**Town of Duanesburg
Planning Board Agenda
September 16th, 2021**

Re: Oak Hill Solar
13590 Duanesburg Road, Duanesburg, NY 12053
Issued for Construction (IFC) Plans
Town Engineer Comment Response Letter

IFC Site Plan Drawings and Summary of Changes Letter

Redesigned pervious access roads

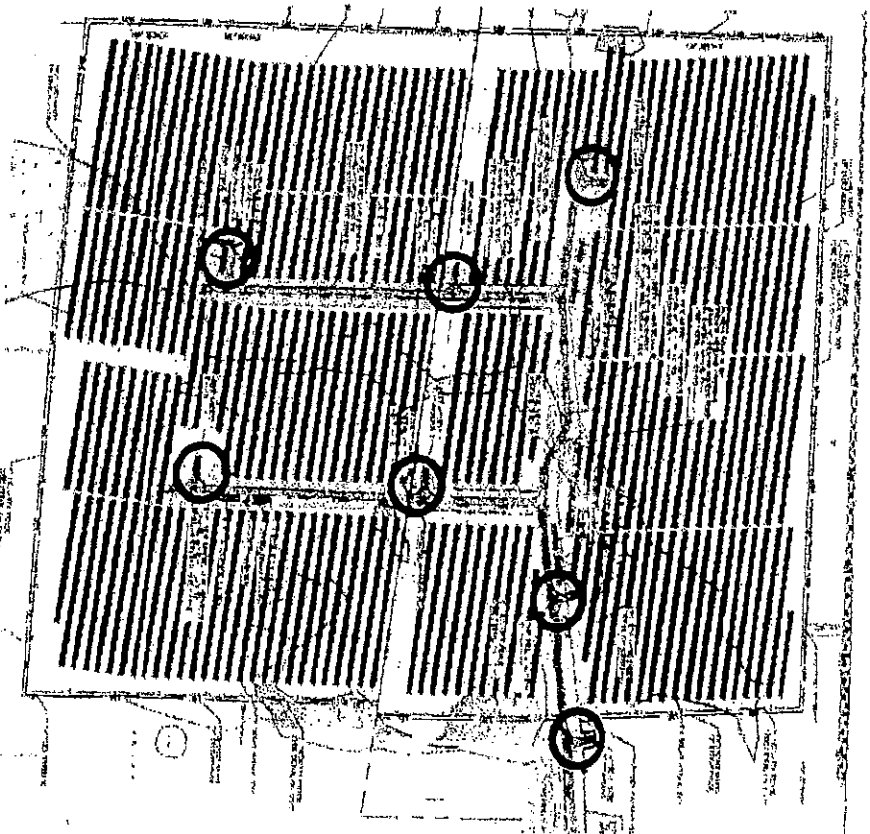
Access Roads Expansion

Original Design - 2019

Current Design - 2021

2021 Solid State Energy Storage Design

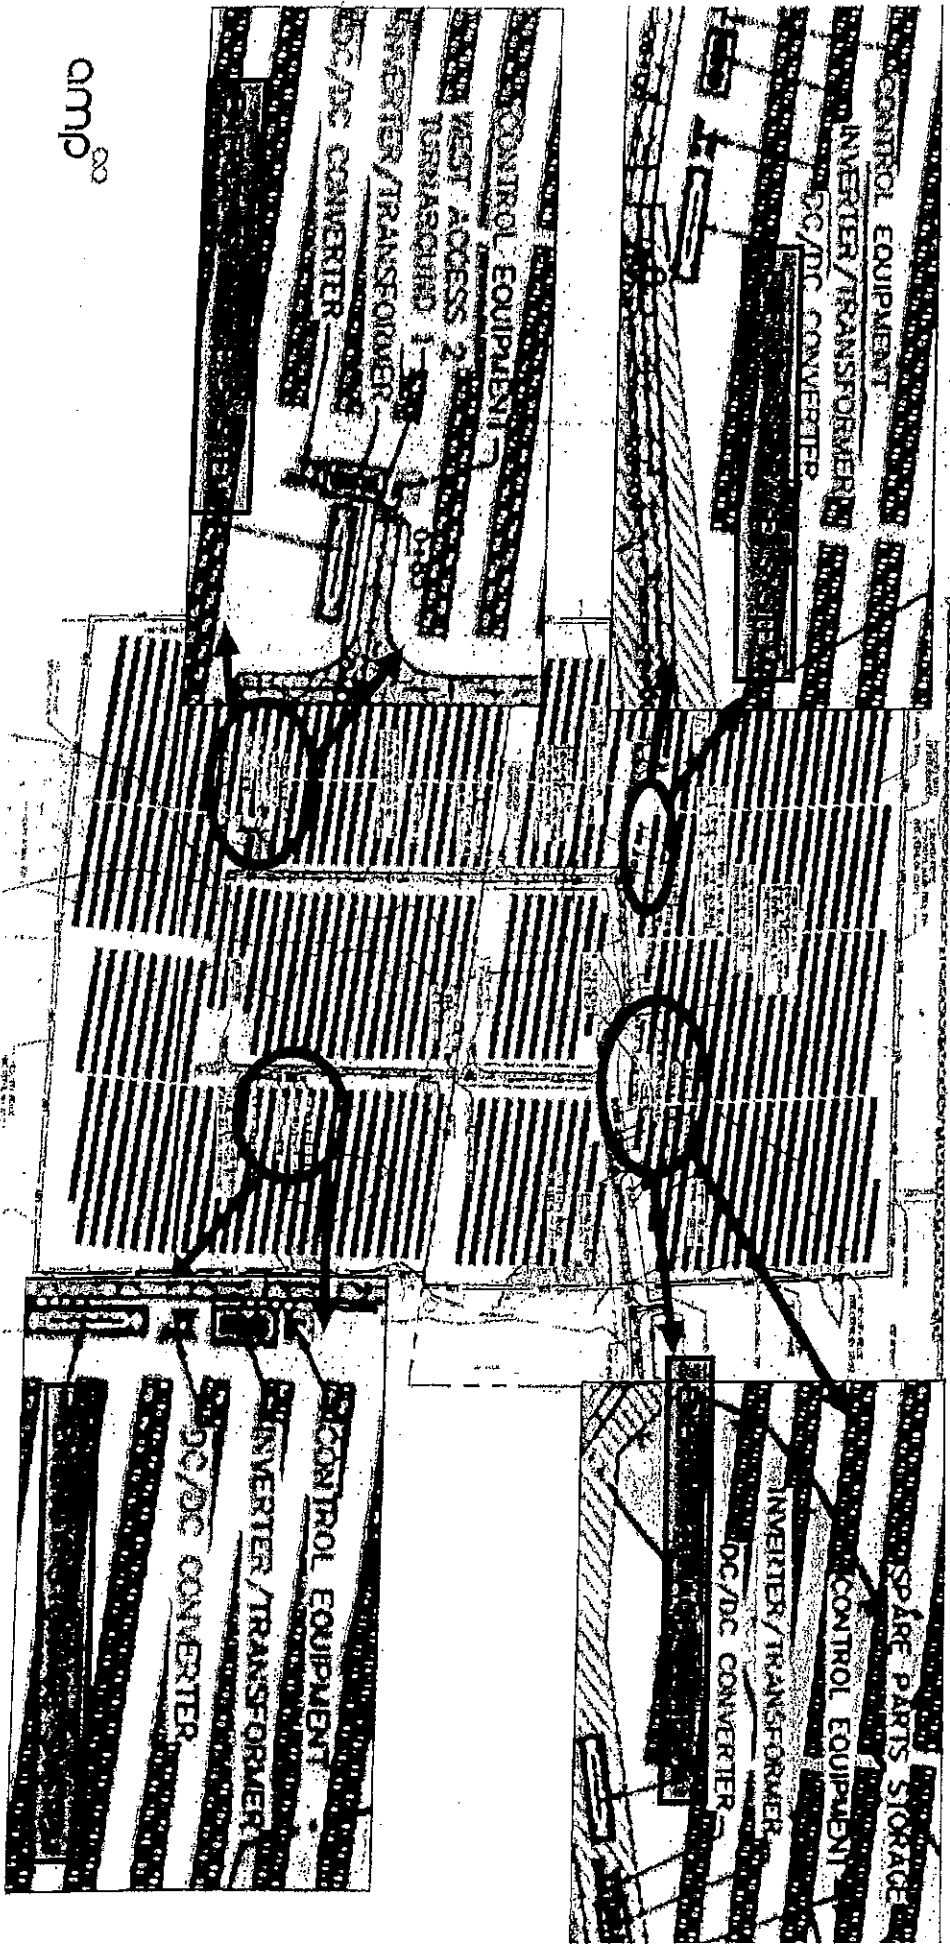
Reduction from 11.78 MWh (2019) to 9.00 MWh (2021), per project

Figure 1. Environmental Resource Mapper indicating missing fresh water wetlands.

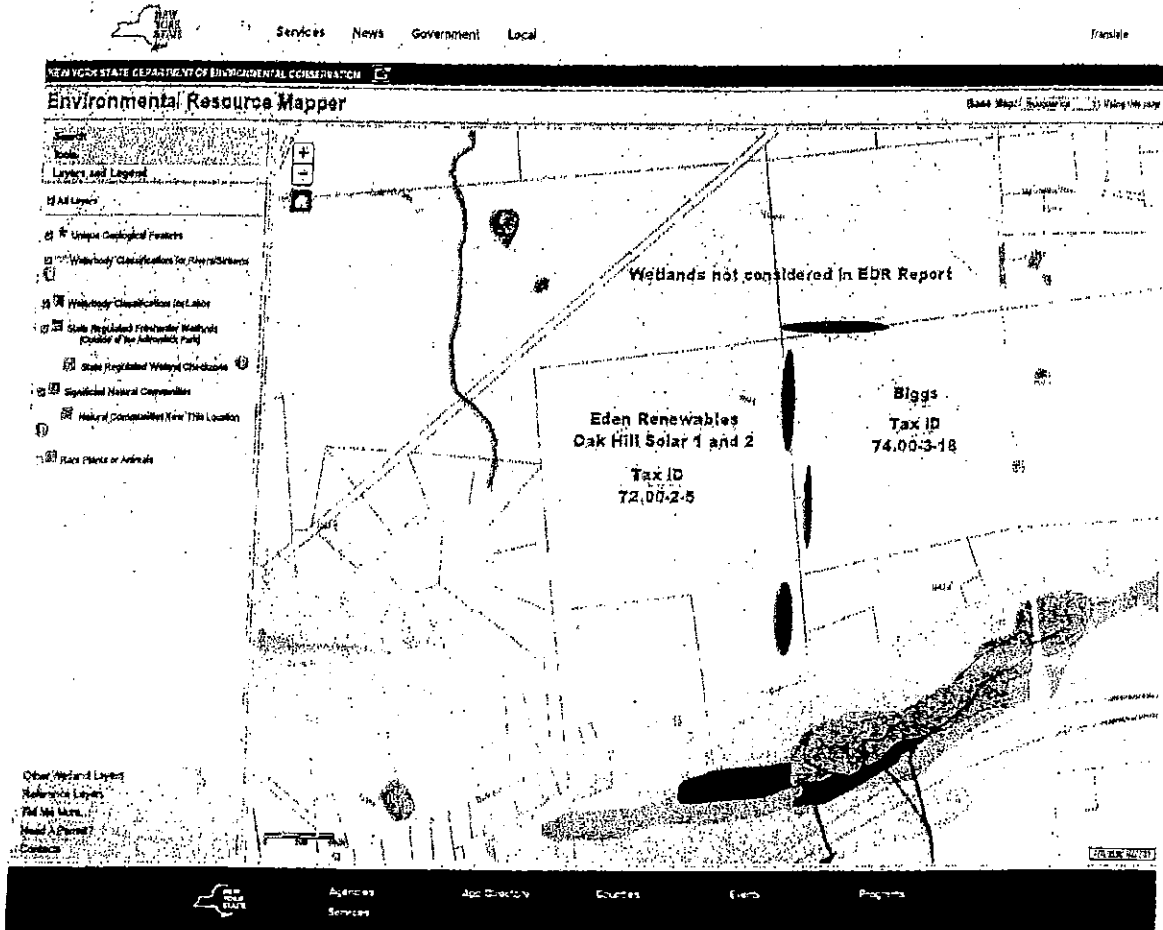
I urge the planning board to reconsider the the project's stormwater impact due to increased access road dimension and newly proposed installation of four 53 foot battery storage containers. These storage containers do not appear on the approved September 2019 site plan sheets 1 through 11. Without a doubt my property will be negatively impacted and the ability to produce hay will be compromised. This will cause me to lose revenue. Ultimately this will unfavorably impact the potential value of the property for alternative uses. Our zoning ordinance protects property values and I urge you to follow our Zoning Law Section 14.6.1.5 e) Adequacy of storm water and drainage facilities; when reviewing the Project.
